# VILLAGE OF ARLINGTON HEIGHTS STAFF DEVELOPMENT COMMITTEE REPORT

**Temp File Number:** T-1648  
**Project Title:** Taylor Morrison Townhomes  
**Address:** 37-45 S. Chestnut St., 36-40 S. Highland St.  
**PIN:** 03-30-425-021 thru 023, 03-30-425-012 thru 014

**To:** Conceptual Plan Review Committee  
**Prepared By:** Sam Hubbard, Development Planner  
**Meeting Date:** February 27, 2019  
**Date Prepared:** February 22, 2019

**Map I – Subject Property and Adjacent Comprehensive Plan Land Designations**

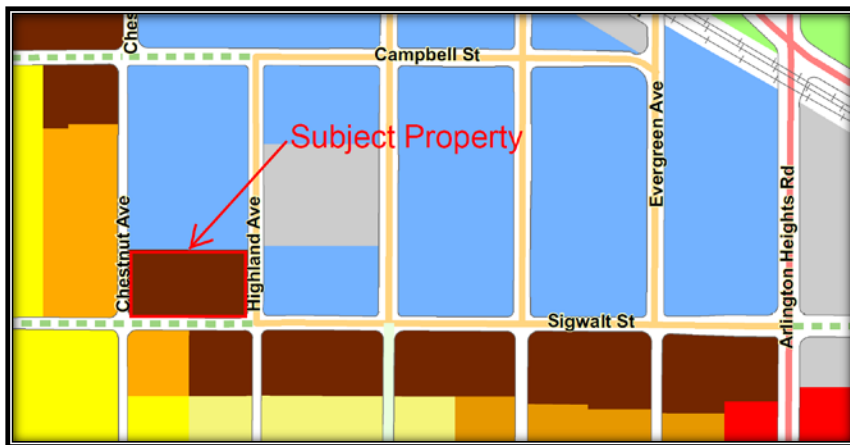
One of the required variations relates to the size of the R-7 Zoning District, which in this instance will be 1.39 acres where code requires a minimum of two acres for land within the R-7 District. Therefore, the following variation is needed:

- **Chapter 28, Section 5.1-7.3, Minimum Area for Zoning District, to allow the R-7 District to be approximately 1.39 acres where code requires a minimum of two acres for the R-7 District.**

The minimum R-7 district size is primarily intended to limit instances of spot zoning on smaller properties that may be contiguous with the B-5 District. However, the Comprehensive Plan designates the site as one part of a larger strip of R-7 zoned land that is contiguous to the subject property, and when considered in sum, this strip of potential R-7 zoning is well over two acres in size. **Map I** (below) illustrates this area, with the subject property outlined in red, the brown areas indicating properties appropriate for the R-7 District, and the blue properties as appropriate for B-5 Downtown District zoning:

When the vision of the Comprehensive Plan is realized, the subject property will no longer be an isolated pocket of R-7 zoning and the variation will no longer be applicable. Additionally, this property is unique in that in order to comply with the Comprehensive Plan designation of “High-Density Residential”, R-7 zoning is required and a variation is needed. For these reasons, the Staff Development Committee is supportive of the requested variation.
